Access Compliance Report

Public Rights-of-Way

(Curb Ramps)

Intersection ID: 43495	Main Street: PROVIDENCE_LN	Cross Street: PRESCOTT_HILL_AV	Location: SE
ADA ID: BCF4E4552C3E	Ramp Type: PerpDiag	Initial Pass/Fail: Fail	Overall Compliance: No
Severity Score: 22.5			
Codes/Mitigation Info/Possible Solution		Field Measurements/Component Compliance

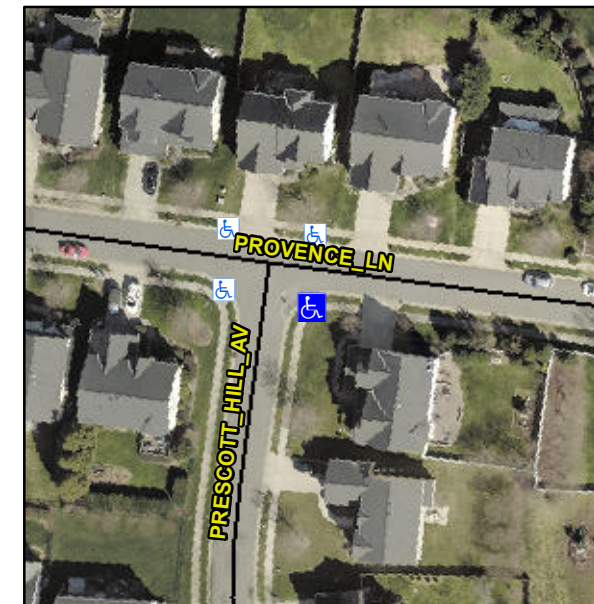
Not Found, R304.5.1, R304.2.2, R304.5.3

Compliance	Description	Data	Compliance	Description	Data
N/A	Ramp Length (in)	46.0	No	Ramp Slope (%)	10.2
No	Ramp Width (in)	43.5	No	Ramp XSlope (%)	2.3
N/A	Flare Type LT	N/A	N/A	Flare Type RT	N/A
N/A	Flare Slope LT (%)	N/A	N/A	Flare Slope RT (%)	N/A
N/A	Flare Traversable LT?	N/A	N/A	Flare Traversable RT?	N/A
N/A	Landing Length (in)	N/A	N/A	DWS Provided?	N/A
N/A	Landing Width (in)	N/A	N/A	DWS Contrast?	N/A
N/A	Landing Slope (%)	N/A	N/A	DWS Length (in)	N/A
N/A	Landing X Slope (%)	N/A	N/A	DWS Full Width?	N/A
N/A	Landing Curb? (Y/N)	N/A	N/A	DWS Offset (in)	N/A
N/A	Shared Landing?	N/A			
N/A	Gutter Ponding?	N/A	N/A	Gutter Slope (%)	N/A
N/A	Gutter Lip Ht (in)	N/A	N/A	Gutter X Slope (%)	N/A
N/A	Painted X Walk1?	No	N/A	Painted X Walk2?	No
	X Walk 1 Direction	To NE		X Walk 2 Direction	To NW
N/A	X Walk 1 Width (in)	N/A	N/A	X Walk 2 Width (in)	N/A
	X Walk 1 Slope (%)	3.8		X Walk 2 Slope (%)	3.9
	X Walk 1 X Slope (%)	1.6		X Walk 2 X Slope (%)	4.4

Remove & Replace Curb Ramp With Two New Directional Ramps or Equivalent.
